LOS CEDROS SUBDIVISION PRELIMINARY OVERALL AREA DEVELOPMENT PLAN

POADP # 625

P.O.A.D.P. REVIEW

SUBJECT: Los Cedros Subdivision POADP Level I T.I.A.

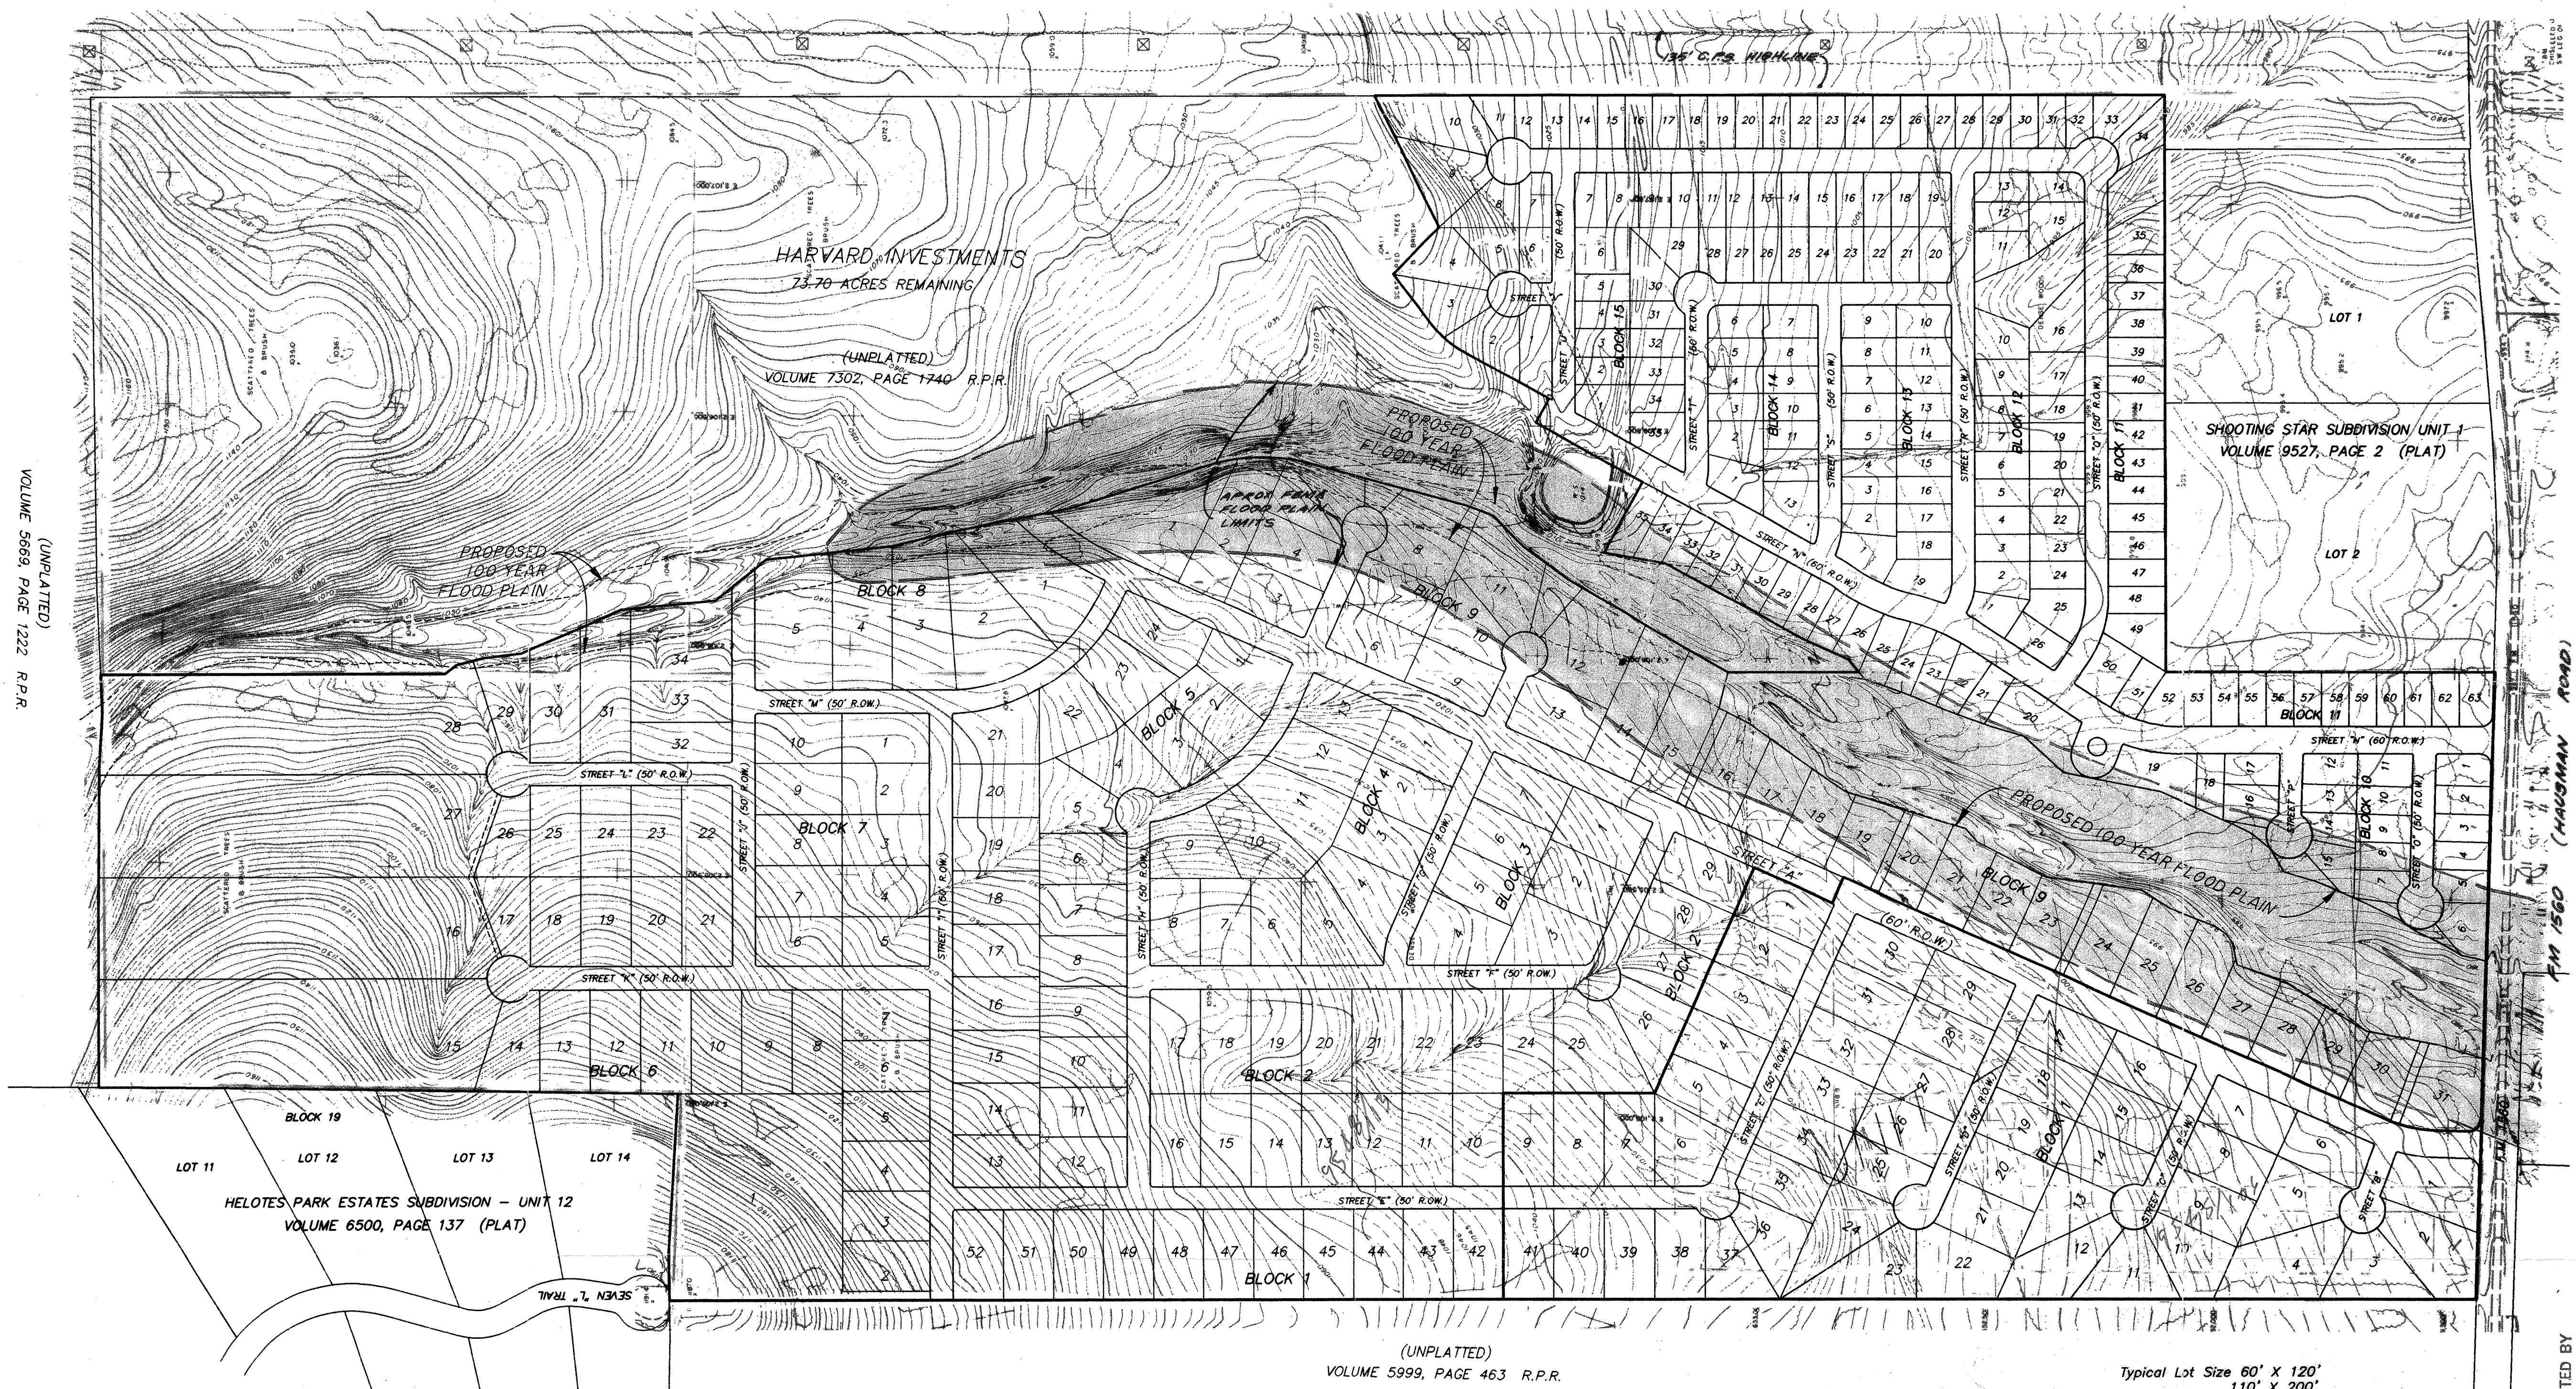
- Based on the topography, a Flood Plain Study and drainage review will probably be required during the platting process.
- Staff recommends that there be no residential frontage on the both of the collector streets.

- In consideration of public safety and convenience, excessive grades by reason of topography should be avoided in street layouts and arrangements.
- This development will probably need to conform to requirements associated with development over the Edwards Aquifer. For additional information about these requirements you can contact SAWS at 704-7305.

- This development will need to comply with tree preservation ordinance #85262. For information about these requirements you can contact Building Inspections at 207-7102.

- It will be expected that you will plat all of the property depicted in your POADP, to include: floodpains, drainage areas and open space.
- I would encourage you to work closely with the school district, so that they can plan accordingly.

For residential development directly adjacent to State ROW, the developer shall be responsible for adequate set-back and/or sound abatement.

Require 20' right of way dedication along the entire FM 1560 frontage.

This development is eligible for a maximum combined total of two(2) access points along the overall FM 1560 frontage. Locations will be as directed by "Regulations For Access Driveways to State Highways". At the time of platting, a 1' non-access easement will be required along the entire FM 1560 frontage, excluding the area of the proposed access points.

A complete copy of the approved WPAP will be required at the time of platting. State right of way will not be utilized for the purposes of treating storm water runoff from adjacent property.
